**バングラデシュ国**  
**持続的な水関連インフラに係る能力向上プロジェクト**

**パイロットプロジェクト報告書**

2017年6月

JICA EXPERT TEAM

図 3.1 パイロット工事平面図 (設計変更後)

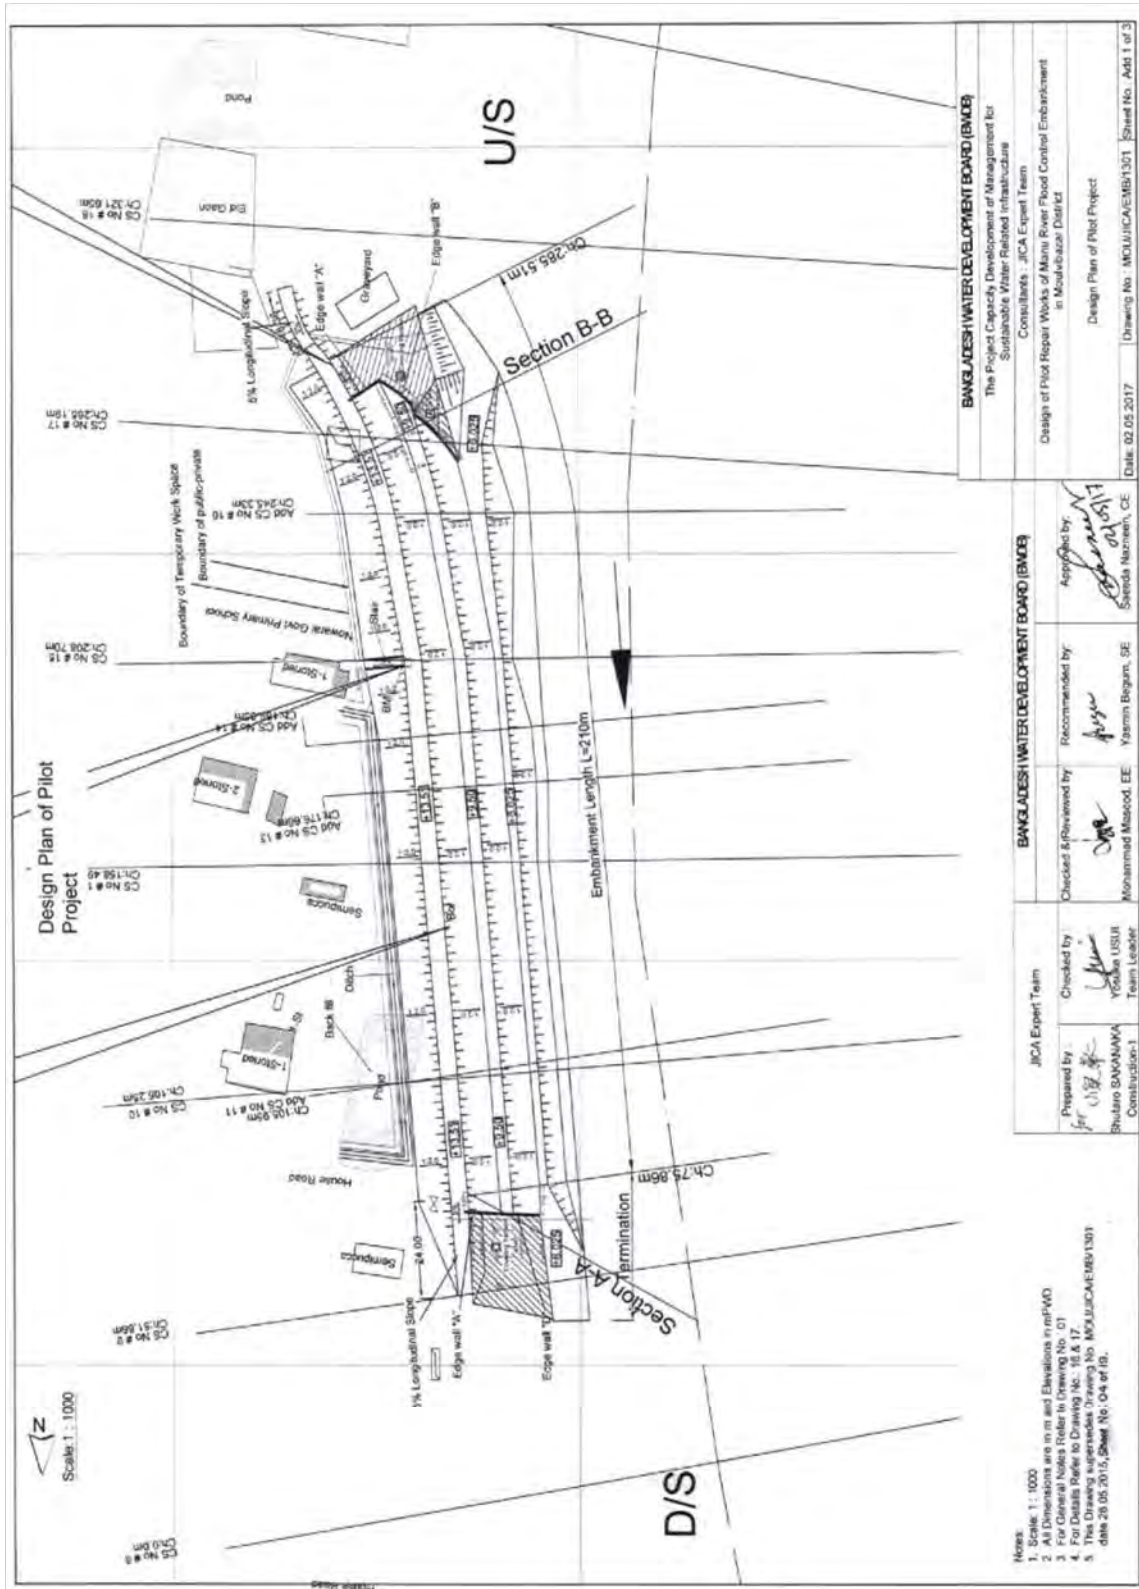
改修堤防上流部の既存堤防への取り付け部設計時には、隣接する「墓地」地区間際まで掘削し、取り付け部を築造し、その後、法面防護部を現場摺り付け盛土とする設計であった。しかしながら、地元住民よりの要望もあり、現況地盤掘削をできるだけ少なくする方法の検討及び設計変更が生じた。2月26日に Dhaka にて BWDB 設計部局で設計変更案について基本合意した後、また、3月11日の設計部局による現地確認後、変更した工事が実施された。

Figure 5 Revised Schedule of April & May 2016 for Pilot Repair Works (Draft-2) April and May, 2016  
 Pilot Repair Work of Manu River Flood Control Embankment in Maulvibazar District up dated on 2016.04.14

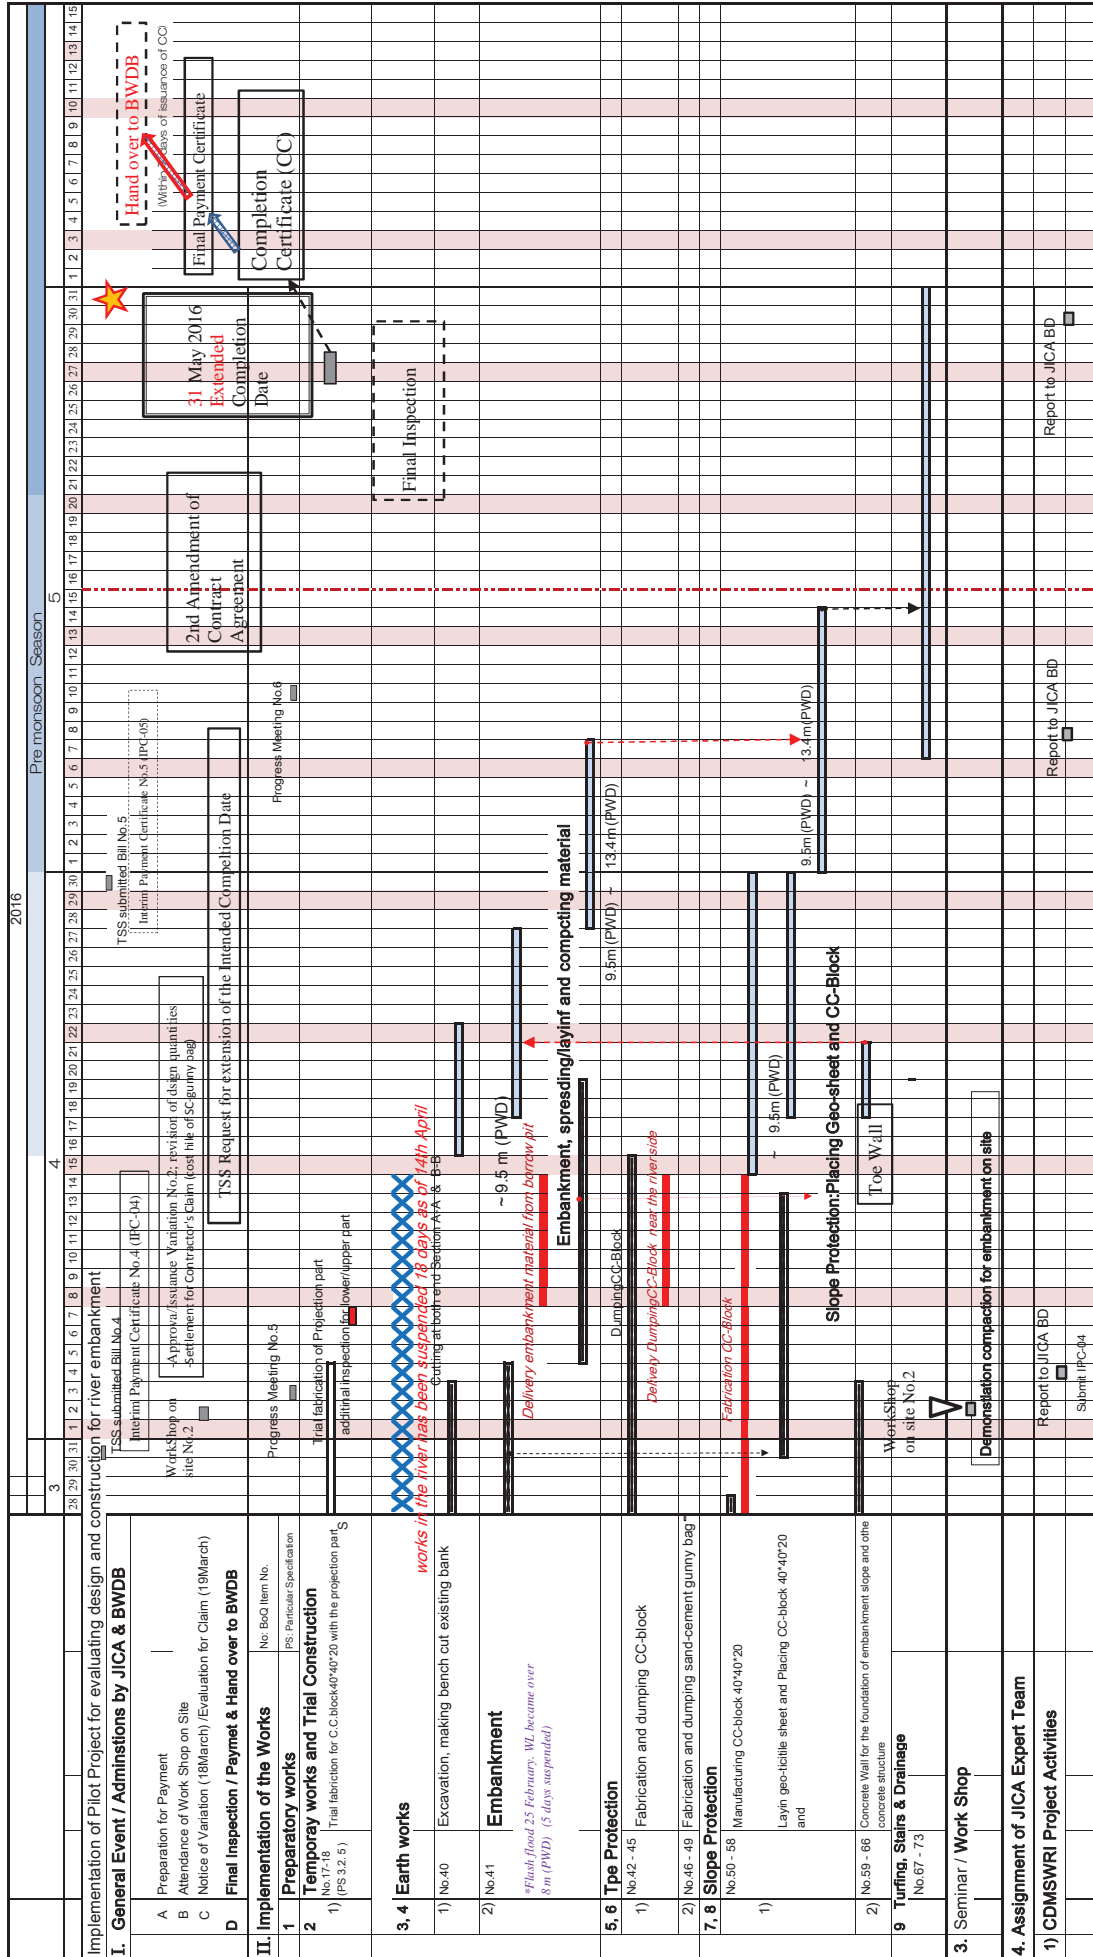
After heavy rainfall in the end of March, the construction time schedule was revised as of 14/Apr/2016, as shown in Figure 5. According to this time schedule, remaining works require about 1.5 month.

Figure 6 Temporary Prevention Measure

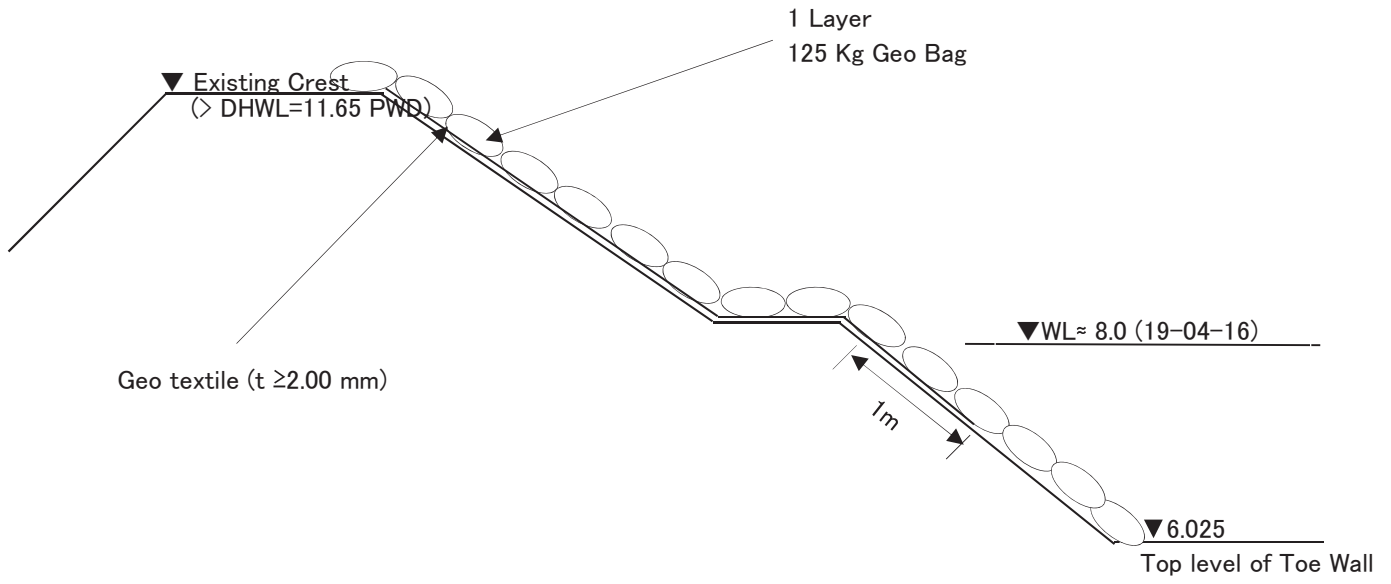
Temporary prevention measure of the PRW was discussed in the field meeting on 19/April/2016 with the Director of Design Circle 1, and recommended as shown in Figure 6 and as follows:

- Based on the practice in the Meghna River and others of BWDB, the embankment area shall be covered with the geotextile sheet (2 mm thickness) and the geotextile sand bags (125 kg, 1 layer).
- The covering extent shall be from downstream end of transition to the existing embankment to the upstream end of transition.
- Sand gunny bags are cheaper than the geotextile sand bags. However the sand gunny bags have not enough durability as the temporary prevention work.
- Materials of the geotextile sand bags and geotextile sheet are common and easy to procure.
